BID #722 – Moorpark College – ANCT ZOO VISITOR BLEACHERS AND ANIMAL SHELTER

ADDENDUM 001, dated 01/29/2026

DRAWING changes and clarifications noted as Addendum 01 and dated 01/29/2026:

C. Class of 2002 Sign

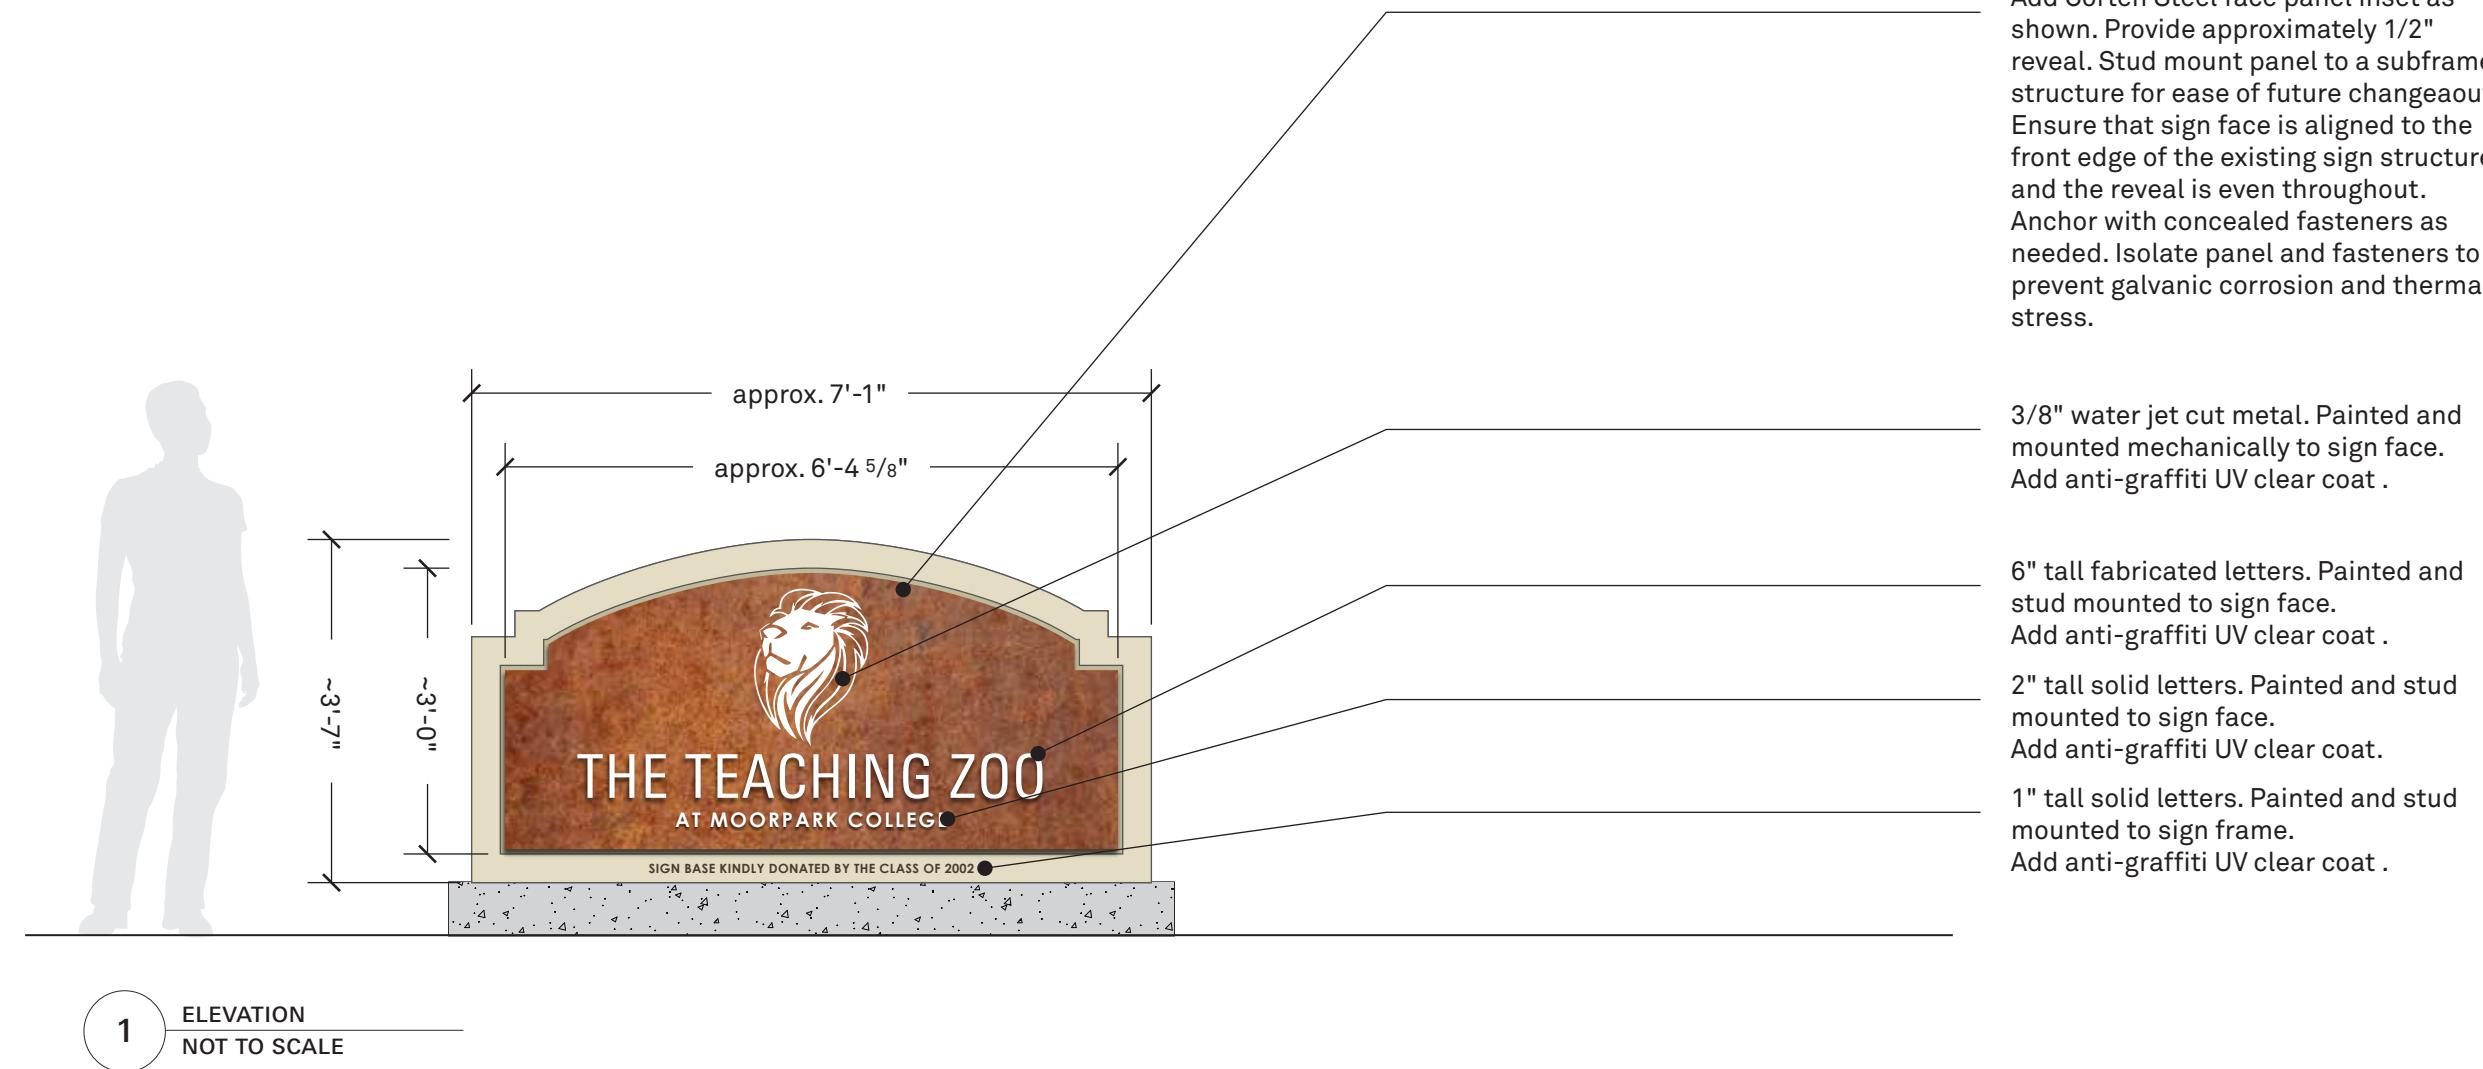
Retrofit existing concrete monument with an inset panel as shown.

Add Corten Steel face panel inset as shown. Provide approximately 1/2" reveal. Stud mount panel to a subframe structure for ease of future changeout. Ensure that sign face is aligned to the front edge of the existing sign structure and the reveal is even throughout. Anchor with concealed fasteners as needed. Isolate panel and fasteners to prevent galvanic corrosion and thermal stress.

D. ANCT Ground Mounted Sign

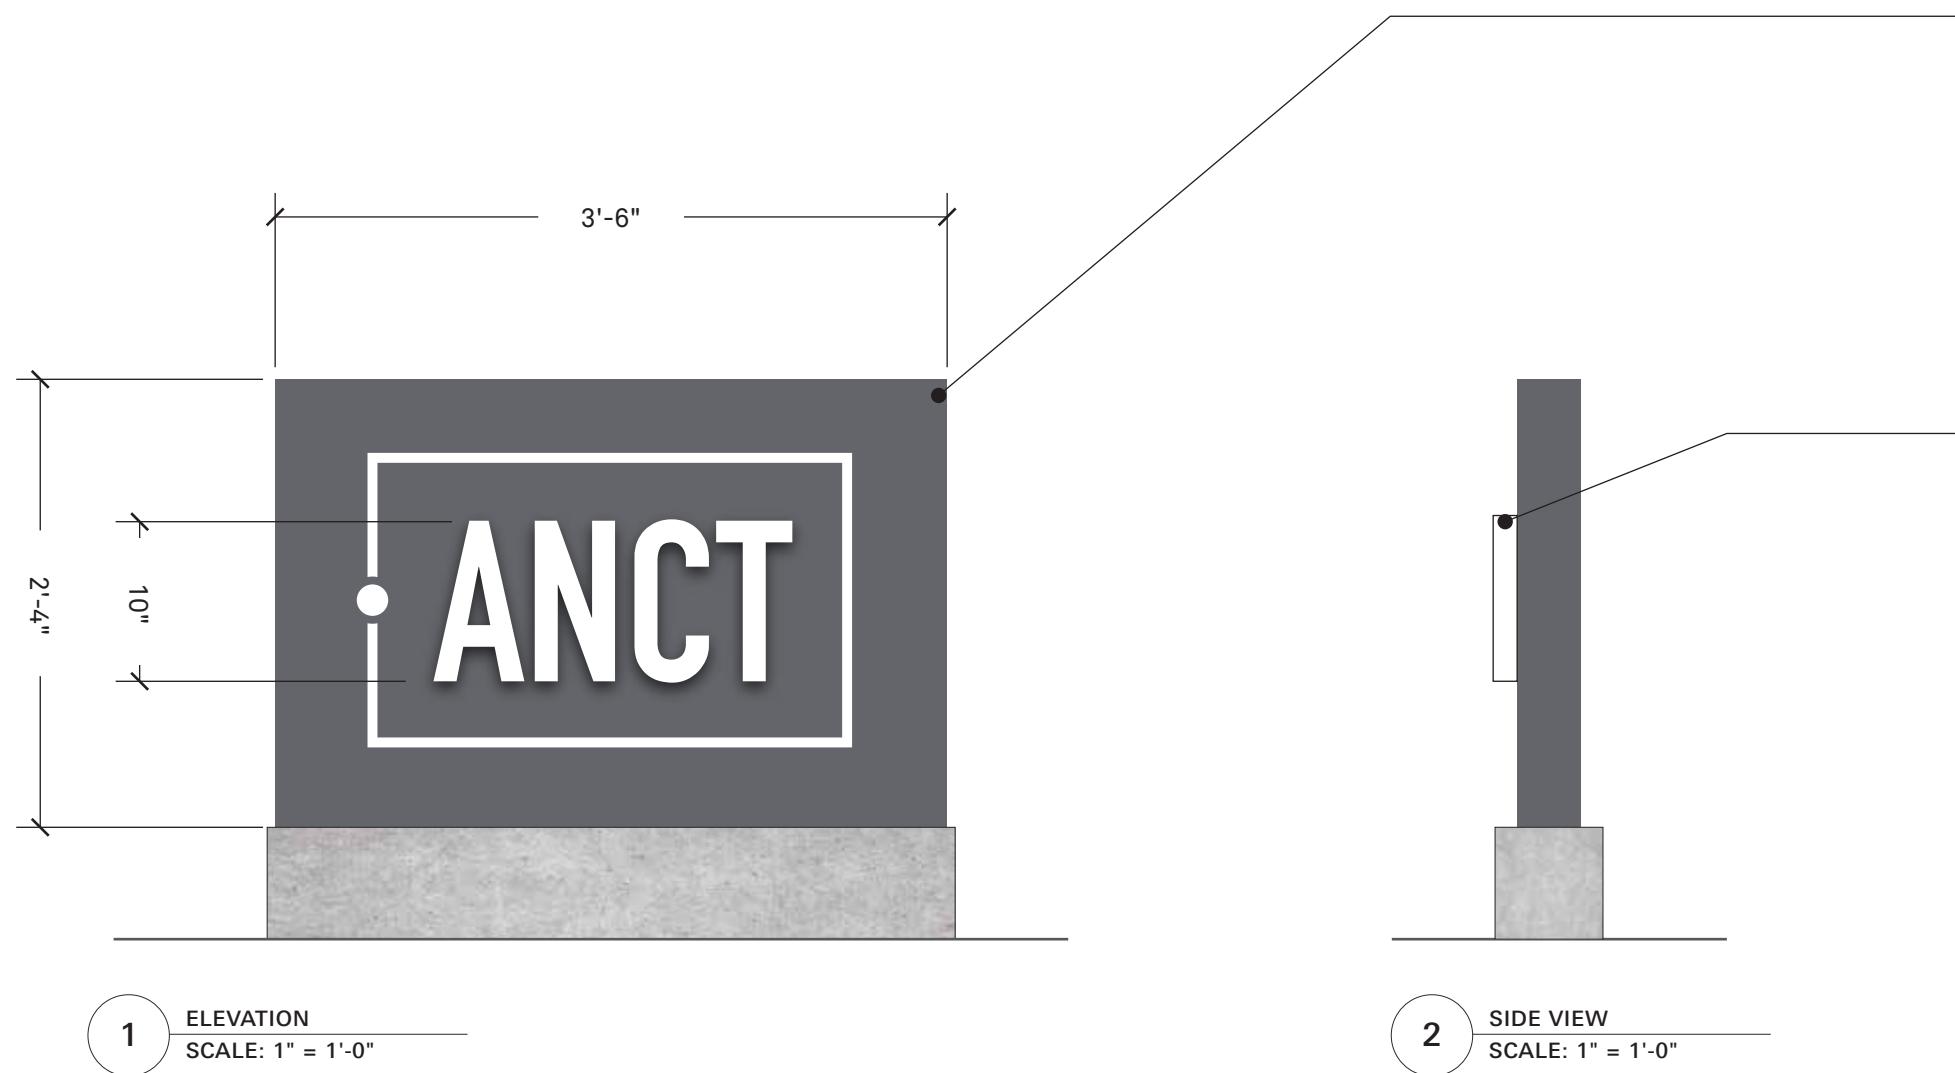
Replace existing aluminum face panel (single sided) plus the applied letterset with visually equivalent assemblies paying special attention to:

Replace face panel with painted 3mm (1/8") solid aluminum composite material (ACM/no LDPE exposed edges). Match mounting to existing structure using available fastener holes or provide stable and durable adaptor. Isolate panel and fasteners from structure to prevent galvanic corrosion and thermal stress. Add anti-graffiti UV clear coat to all painted surfaces.

E. ANCT Letters

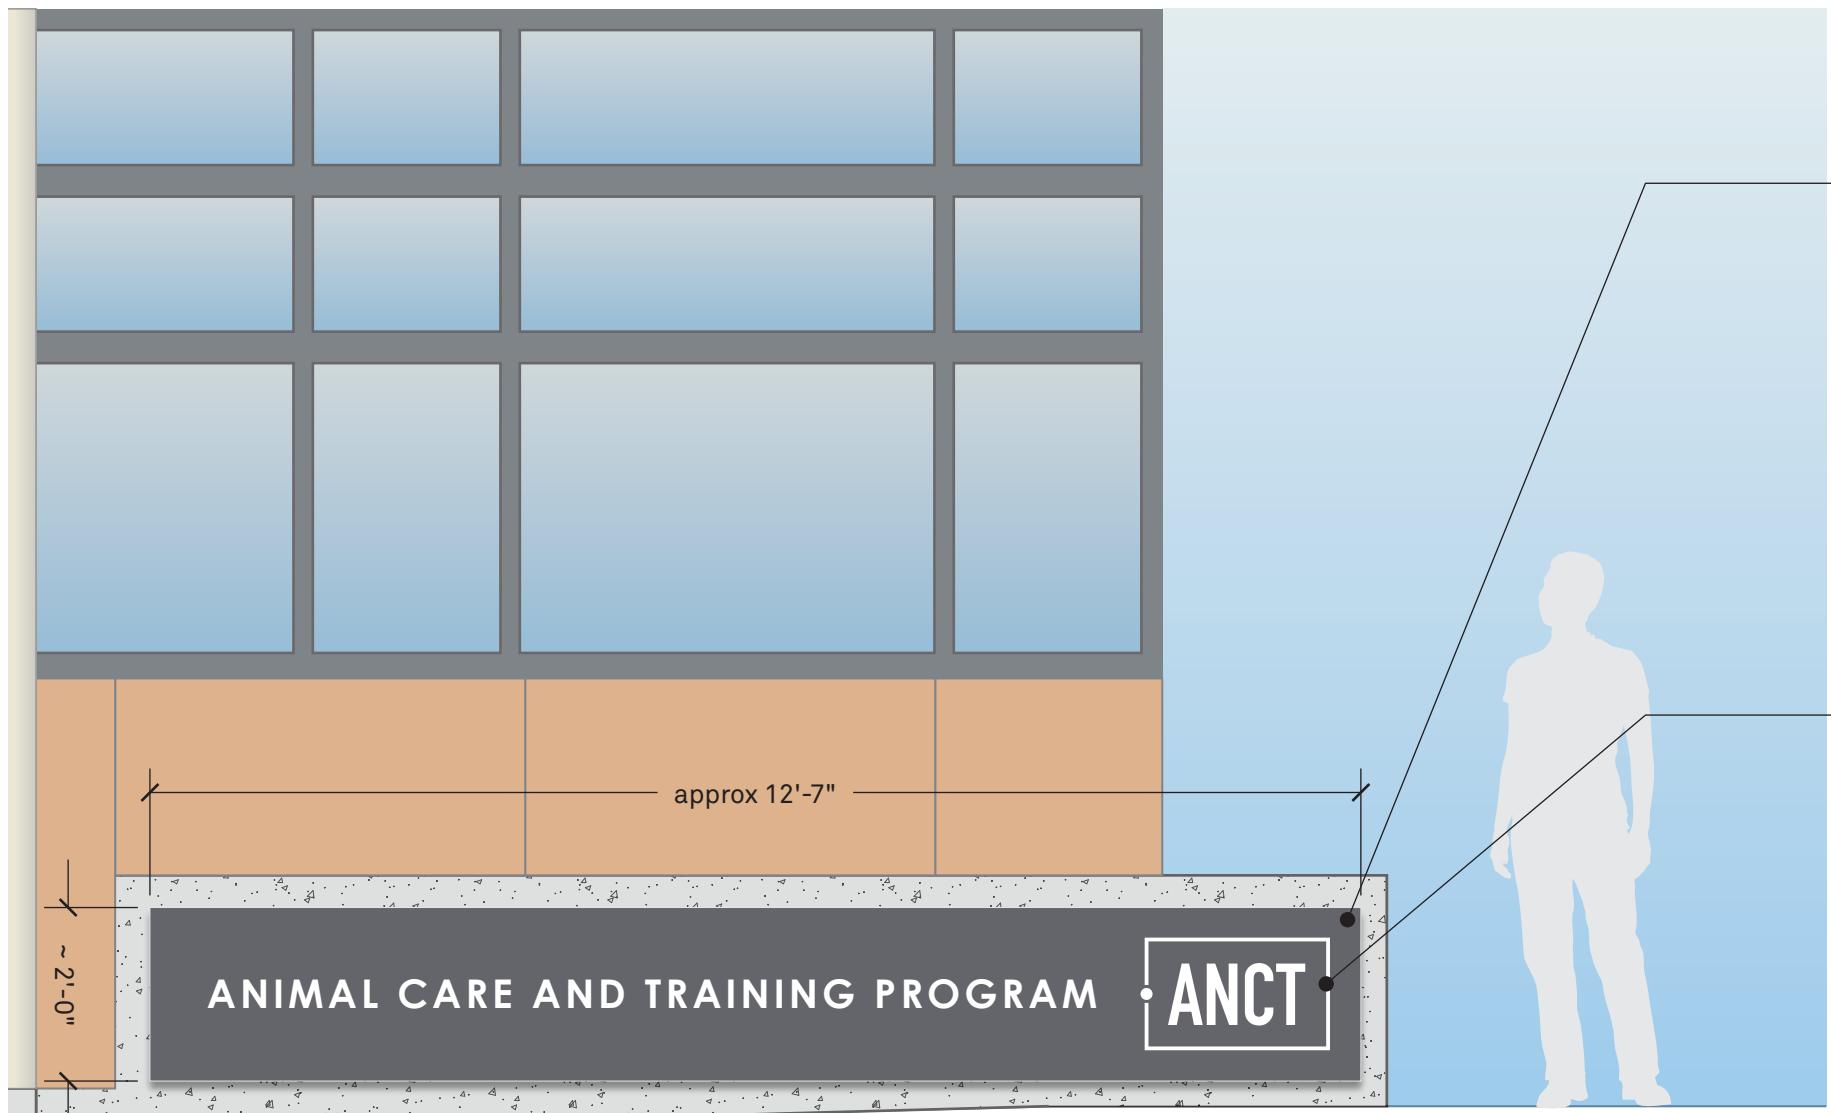
Replace existing letters over concrete bench wall with a fabricated graphic panel and a subframe mounting structure as shown.

Non-illuminated fabricated aluminum wall box 1-1/2" deep stud mounted to a subframe structure for ease of future changeout. Internal stiffeners required to prevent oil-canning across long span. All seams continuously welded, ground smooth. Anchor with concealed fasteners as needed. Isolate panel and fasteners to prevent galvanic corrosion and thermal stress. Concealed weep slots at bottom return if needed. Painted with a high-performance two-part polyurethane paint system. Clear anti-graffiti coating on all exposed surfaces. Satin finish.

1/2" deep aluminum waterjet cut logo and letters, painted with a high-performance two-part polyurethane paint system. Clear anti-graffiti coating on all exposed surfaces. Satin finish.

F. ANCT Wall Letters

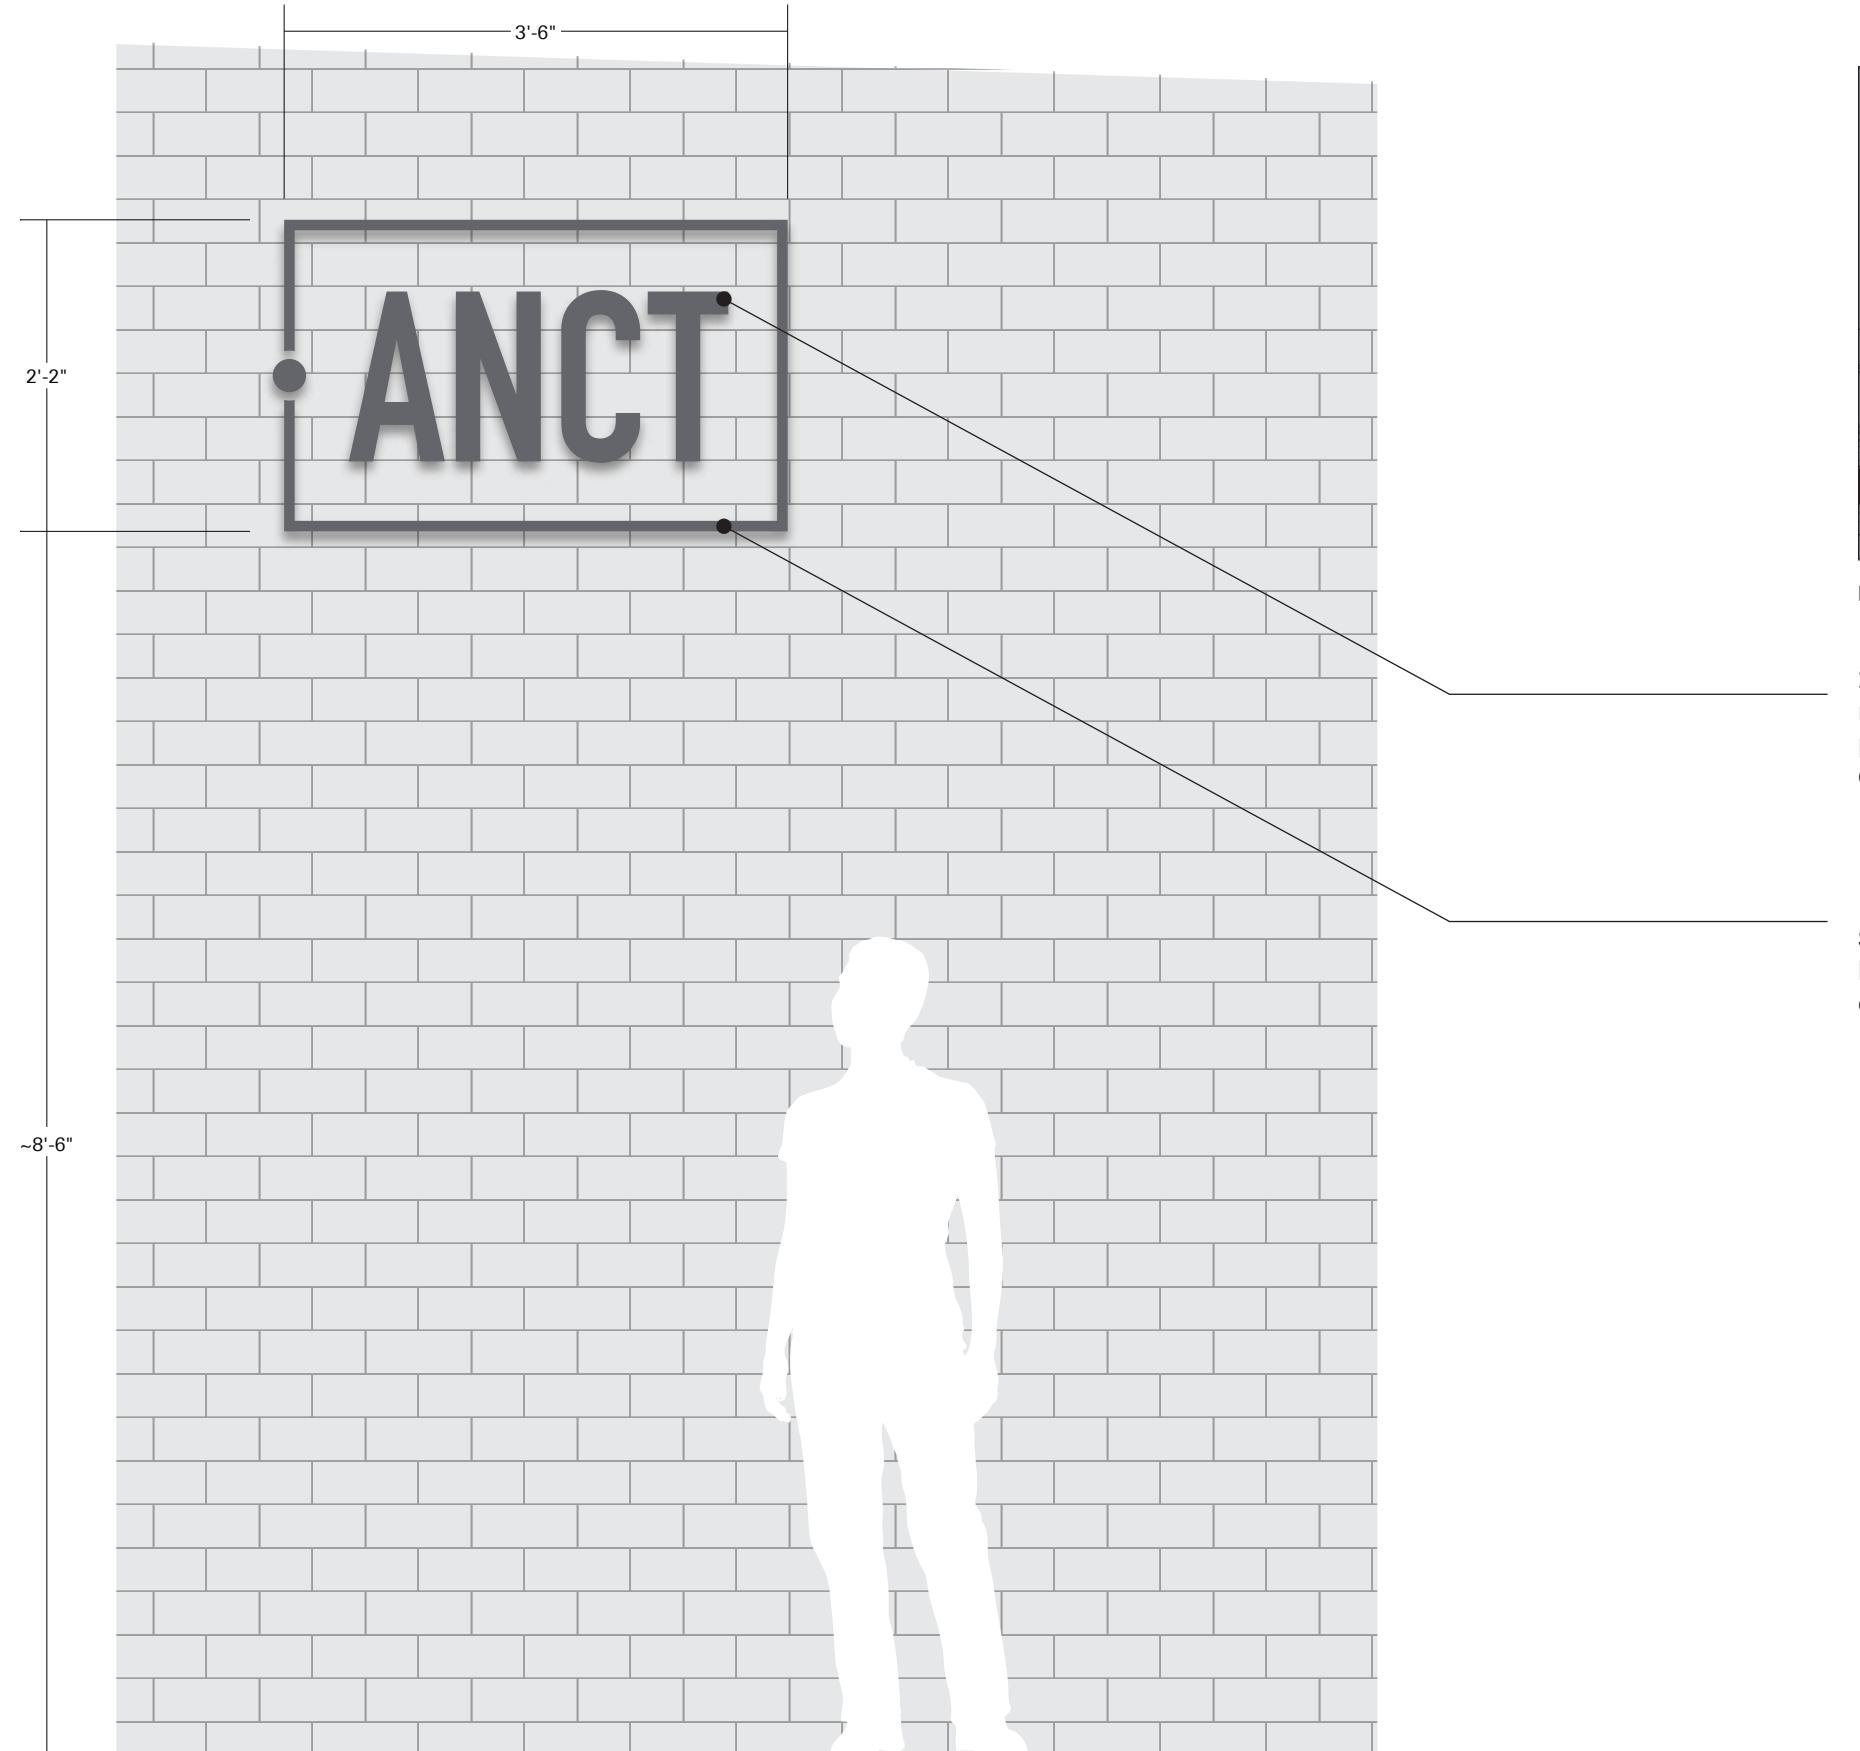
Replace existing wall mounted sign with new dimensional letters.

2 1/2" thick fabricated letters stud mounted. All exposed surfaces to have painted satin finish and protective clear coat.

1" thick fabricated square frame Stud mounted. All exposed surfaces to have painted satin finish and protective clear coat.
